May 2018
FL762AB
NHTSA #18V-163
Transport Canada #2018-123

Subject: FCCC Motorhome Power Steering Hose Routing

Models Affected: Specific Freightliner Custom Chassis X-Line chassis equipped with Cummins ISL engines and manufactured January 21, 2010, through December 22, 2015.

Fig. 1, Power Steering Hose with P-Clip (body removed for clarity)

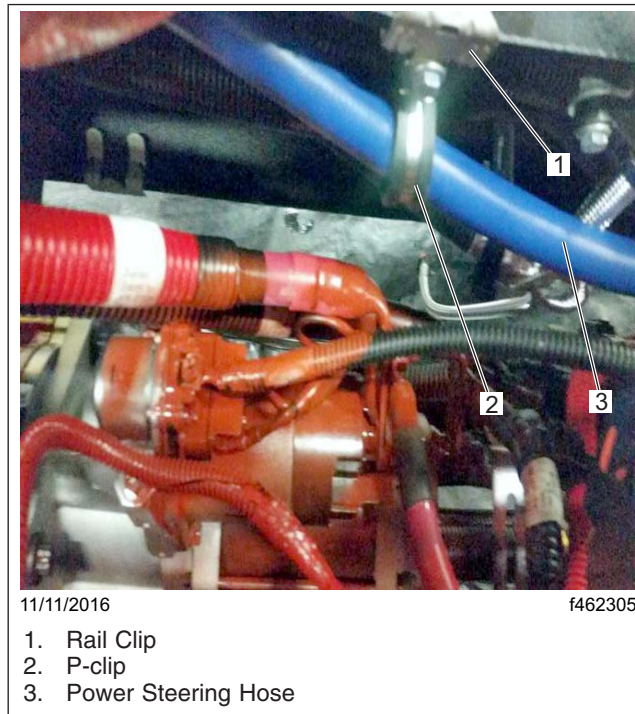
On certain motorhome chassis, the high pressure power steering hose may be routed with inadequate clearance between the hose and a power stud on the starter motor. This may cause the hose to chafe against the power stud on the starter, potentially leading to arcing and, in addition, may cause loss of fluid, short circuit, and melting. Electrical arcing in the presence of leaking power steering fluid can increase the risk of a fire.

The high pressure power steering hoses will be rerouted to provide adequate clearance from the starter stud.

1. Install a rail clip on the top flange of the frame rail, just above the starter.
2. Using a P-clip, bolt, nut, and washer, secure the power steering hose on the rail clip. See [Fig. 1](#). Tighten the nut 72 lbf-in (813 N-cm).
3. For additional security, install tie bands around the hose to the harness near the frame rail within 18 inches (46 cm) of the P-clip.
4. Clean a spot on the base label (Form WAR259). Write the recall number, FL762, on a completion sticker (Form WAR260), and attach it to the base label.
